NO: VS-070
DATE: February 2016

PRODUCT: FZ-SF, FZ-SP Vision Sensor Amp
TYPE: Modification Notice

Amplifier of 300,000-pixel Small Digital Camera Flat Type Model FZ-SF and Pen Type Model FZ-SP Modified

Detail of Differences

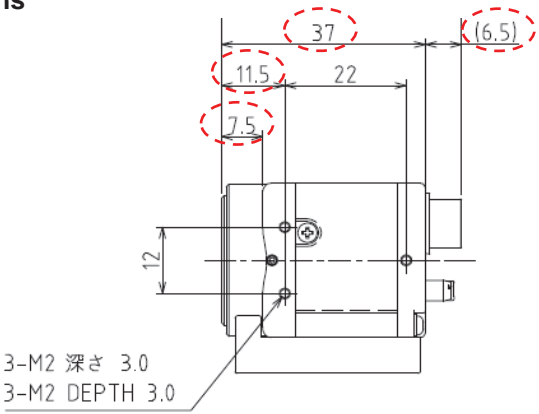
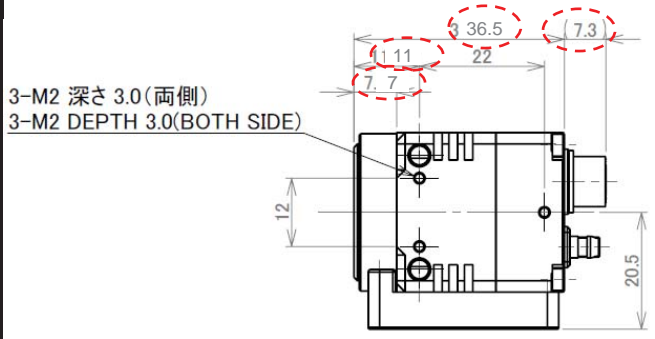
Reason for modification: Improve purchasing efficiency:

- The discontinued electrical parts have been changed.
- The mechanical parts of FZ-S/SC series are not changed

Before the change	After the change
<p>Appearance of Amplifier Printing on the Case : Yes</p> 	<p>Appearance of Amplifier Printing on the Case : No</p> 
<p>Dimensions</p>  <p>3-M2 深さ 3.0 3-M2 DEPTH 3.0</p>	<p>Dimensions</p>  <p>3-M2 深さ 3.0(両側) 3-M2 DEPTH 3.0(BOTH SIDE)</p>
<p>Fixed Attachment The number of the screw for the plate : 4 pcs.</p> 	<p>Fixed Attachment The number of the screw for the plate : 3 pcs.</p>
